Southdown View - Emsworth
NGR SU 75200:07899 + - 2M
Soil and Porosity Report with foul
drainage recommendations

Document Title	REPLY TO QUESTIONS RAISED
Document Description	Surface Water disposal and foul drainage
Document Reference	WCI Ref 25P124

Questions asked by Jon Driver to Rachel Ballam concerning a foul drainage report ref WCI Ref 25P124 dated 09.07.2018. Reply in bold red type

Location of the Cesspool and the water harvesting tank (previously a septic tank) shown in the photograph below.

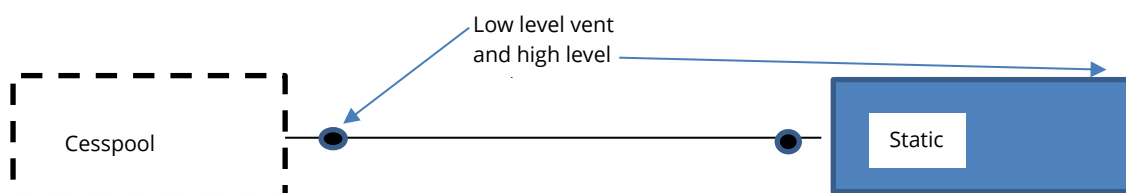
My understanding is that the plans indicated the tank to be used was 'existing' (to be retained), and the schematic / product information provided previously was for an open system septic tank (by implication, with leach field) which the attached report has confirmed to be unsuitable. What is missing is the proposal - i.e. the existing is unsuitable, so we need a proposal - or at least confirmation that the proposal put forward in the attached report will be implemented. **The existing septic tank will not be used for foul drainage – as reported in the last paragraph of the report dated 09.07.18 but used for rain water harvesting or filled in.**

Confirm the existing septic tank will not be used for foul drainage and would be used for rain water harvesting only or filled in.

Cesspool with inlet 450mm manhole chamber – pipe line fall 1:60 with manhole at start of the drainage run and the whole system soil vented at the Cesspool and high level soil vent at the Static.
